**PORT TOWNSEND HEARING EXAMINER
PUBLIC HEARING AGENDA
CITY HALL COUNCIL CHAMBERS, 540 WATER STREET**

- A. LUP22-019 Preliminary Plat and Plat Alteration- The Plat of Pods at the Vineyards**
1. Staff Report
 2. Testimony by the Applicant
 3. Public Testimony
 4. Rebuttals
 5. Hearing Examiner Summary

1. Davos Capital LLC, with partners Steve and Ann Raab (collectively “Applicant”), have submitted application for a preliminary Plat with Plat Alteration (“Plat”) named *Pods at the Vineyard* (“PAV”) (Exhibit A – *Preliminary Plat application with cover letter, rain garden and prairie habitat source material, and revised Plat/Plat Alteration map*; Exhibit B – Site Plan, Shts. 1-4 including Tree Conservation and Landscaping, subject *property deeds, topographic survey map*; Exhibit C - Revised Preliminary Civil Plans, dated Jan. 17, 2024; and, Exhibit D – Revised Stormwater Plan and Report, dated Jan. 17, 2024. PAV creates 17-lots for detached residential development over roughly three (3) + acres. One (1) lot at PAV already contains an existing single-family residence. The property’s current legal description is on pg. 1, above, and in the deeds of Ex. B to this staff report.

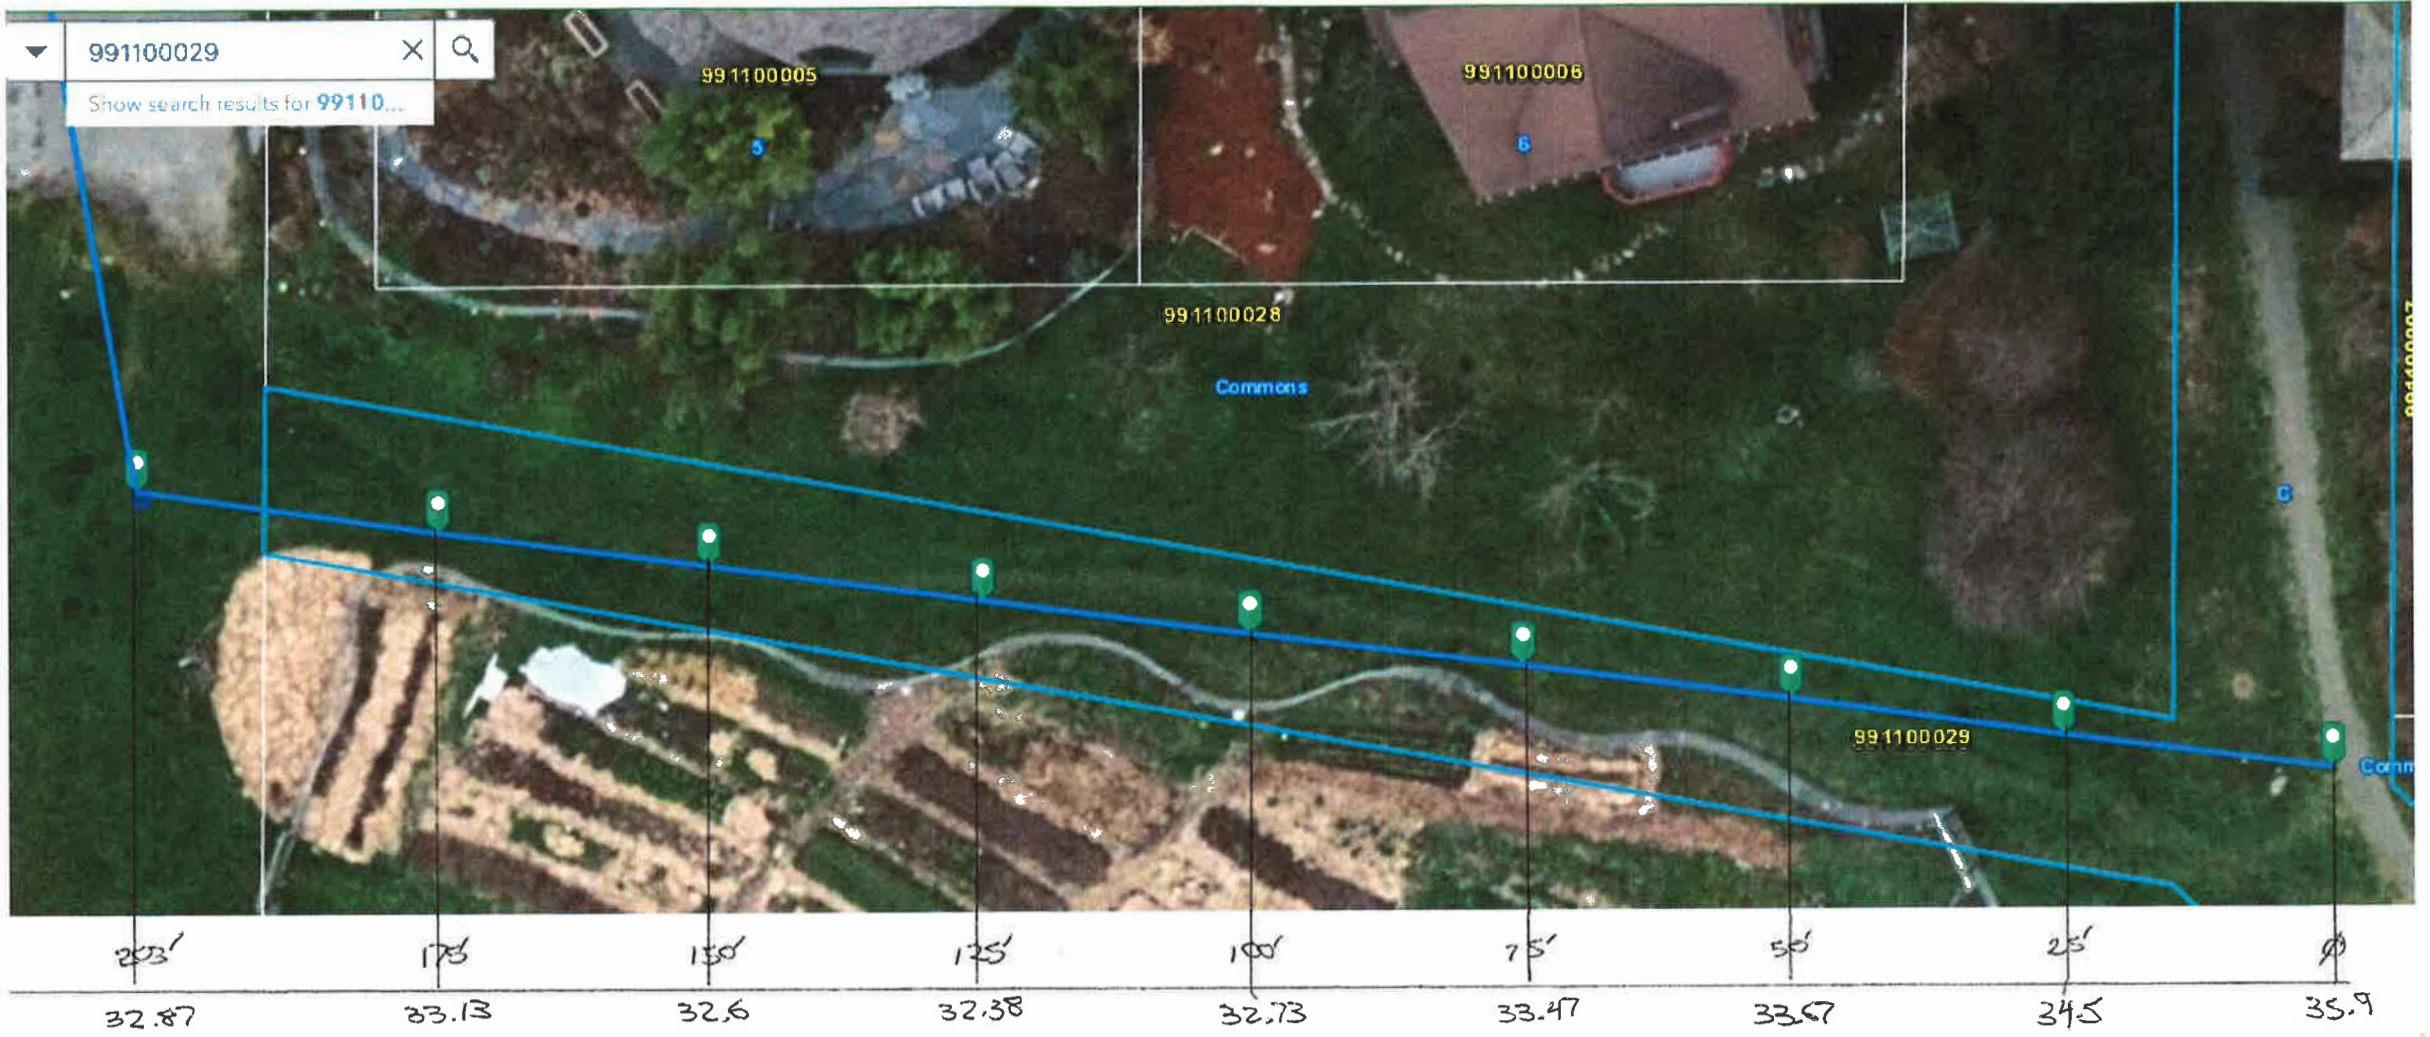
- o. While sheet C-1 describes "approximate ground heights" city codes require "finished ground elevation" over the pipe be specified, pipe pitch noted. C-1 does not describe finished ground elevation or pipe pitch.

- u. Sheet C-1 states rim elevation at their sewer maintenance hole at 203' is 34.3'. Laserfiche found the current ground level at the 203' manhole was 32.87'. This is a difference of 1.43'. C-1 showed 2' of cover where Laserfiche found 6".

- (e) If the RW C59 as-built invert height is correct, sheet C-1 must be recalculated, redrawn, and replaced. All decisions coming from C1 would be revisited.

I created laserfiche map(*1) and a sewer study graph (*2) comparing the Pods at the Vineyard's Civil Engineering Sheet C1 data. (*3) I also transferred data onto PAV's Sheet C1) cross sectional graph to provide clarity for the Port Townsend Public Works department's review.

The proposed sewer line needs added soil to have a depth of fill of 1' over 125' of the run. To have 2' of soil will require fill for approximately 175'
